Design Changes Summary

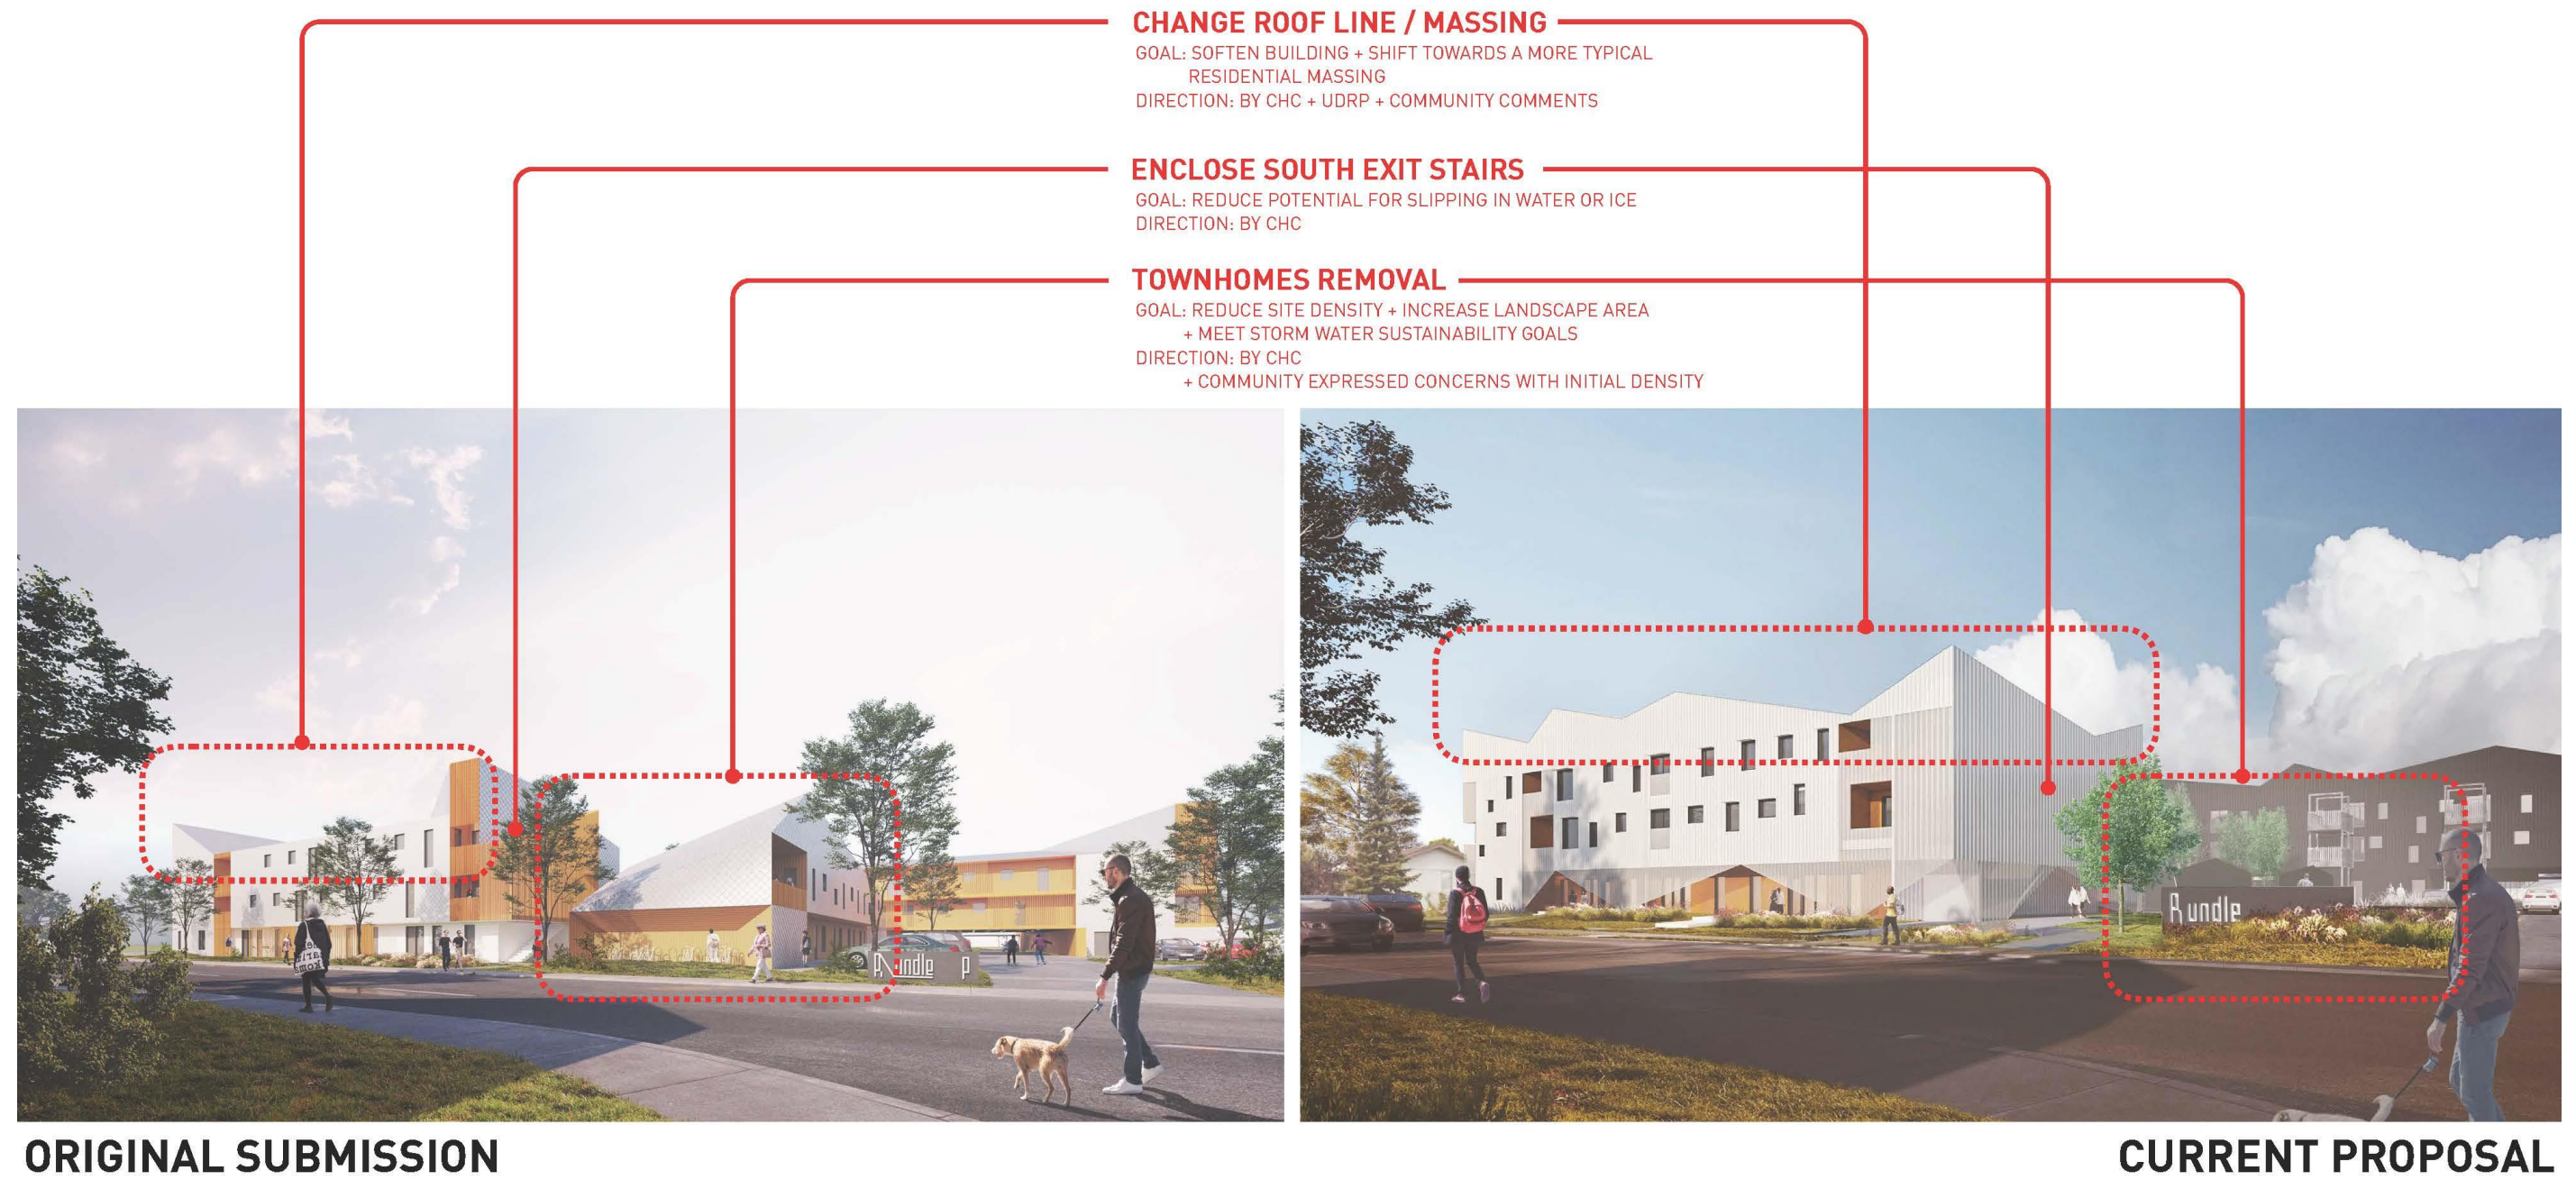
CHANGE ROOF LINE / MASSING

GOAL: SOFTEN BUILDING + SHIFT TOWARDS A MORE TYPICAL
RESIDENTIAL MASSING
DIRECTION: BY CHC + UDRP + COMMUNITY COMMENTS

CHANGE CLADDING

GOAL: USE MATERIAL CHC MAINTENANCE TEAM IS
ACQUAINTED WITH
DIRECTION: BY CHC

CHANGE OF GROUND FLOOR SCREEN + MATERIAL

GOAL: ADD BUILDING ARTICULATION + ENHANCE GROUND LEVEL STREET EDGE
WITH MATERIAL AND COLOUR AT RECESSED GROUND FLOOR
DIRECTION: BY CHC + UDRP + COMMUNITY COMMENTS

CHANGE + INCREASE WINDOW SIZE

GOAL: INCREASE WALL ANIMATION + IMPROVE ACCESS TO DAYLIGHT +
IMPROVE TENANT COMFORT
DIRECTION: BY CHC + UDRP + COMMUNITY COMMENTS

CHANGE CLADDING

GOAL: USE MATERIAL CHC MAINTENANCE TEAM IS
ACQUAINTED WITH.
DIRECTION: BY CHC

ENCLOSE SOUTH EXIT STAIRS

GOAL: REDUCE POTENTIAL FOR SLIPPING IN WATER OR ICE
DIRECTION: BY CHC

CHANGE ROOF LINE / MASSING

GOAL: SOFTEN BUILDING + SHIFT TOWARDS A MORE TYPICAL
RESIDENTIAL MASSING
DIRECTION: BY CHC + UDRP + COMMUNITY COMMENTS

JULIETTE BALCONIES

GOAL: PROVIDE JULIETTE BALCONIES AT ALL UNITS WITHOUT A BALCONY
DIRECTION: BY CHC + COMMUNITY COMMENTS

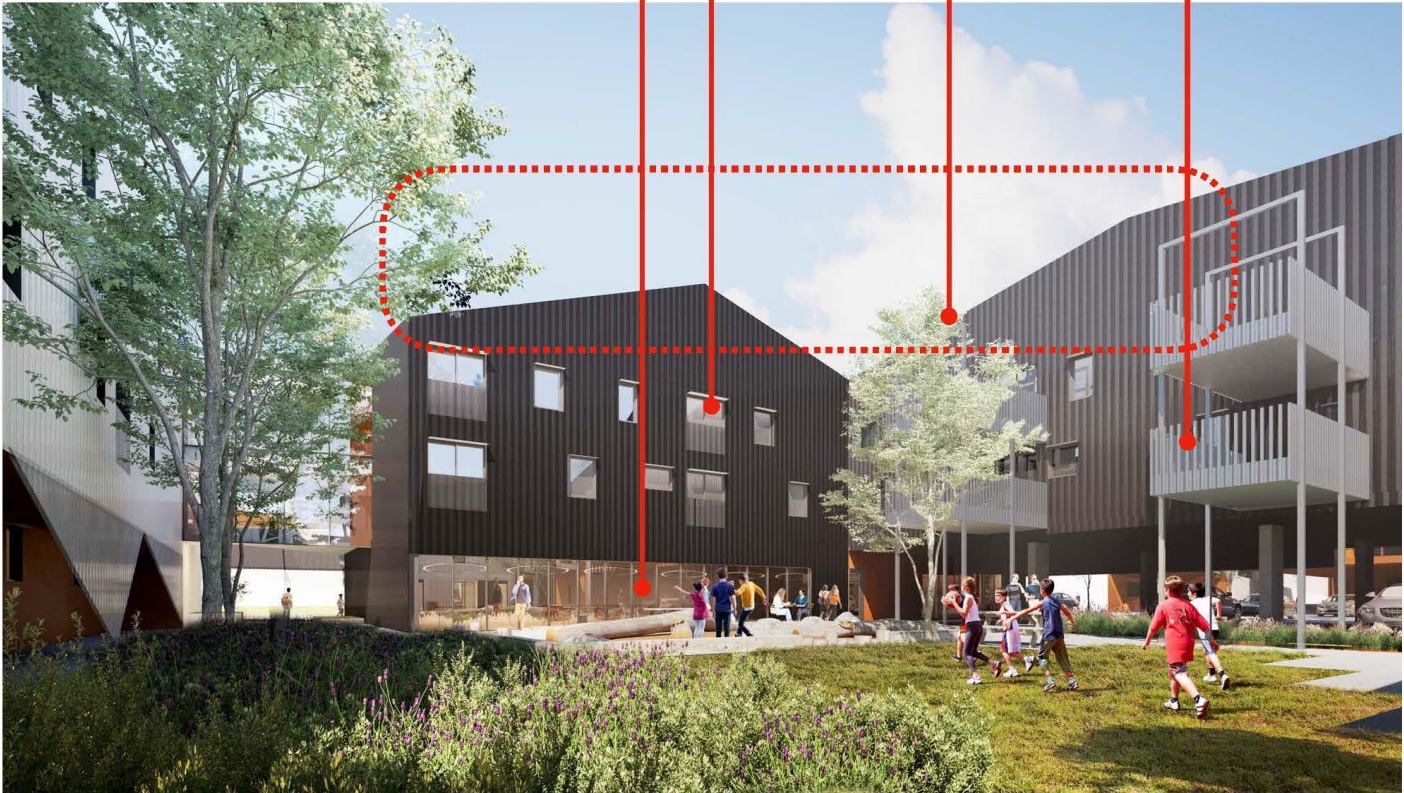
INCREASE AMENITY SIZE

GOAL: INCREASE CONNECTION BETWEEN INDOOR AND OUTDOOR
AMENITY AREAS AND CREATE OPPORTUNITIES FOR ACTIVITIES TO SPILL OUT FROM ONE TO THE OTHER
DIRECTION: BY DESIGN TEAM

LARGER STEP-OUT BALCONIES FOR ACCESSIBLE UNITS

GOAL: PROVIDE LARGER STEP-OUT BALCONIES THAT WOULD ALLOW SOMEONE IN A
WHEEL CHAIR EASY USE OF BALCONY AND BRING THEM INTO THE COURTYARD ACTIVITY
DIRECTION: COMMUNITY COMMENTS + DESIGN TEAM
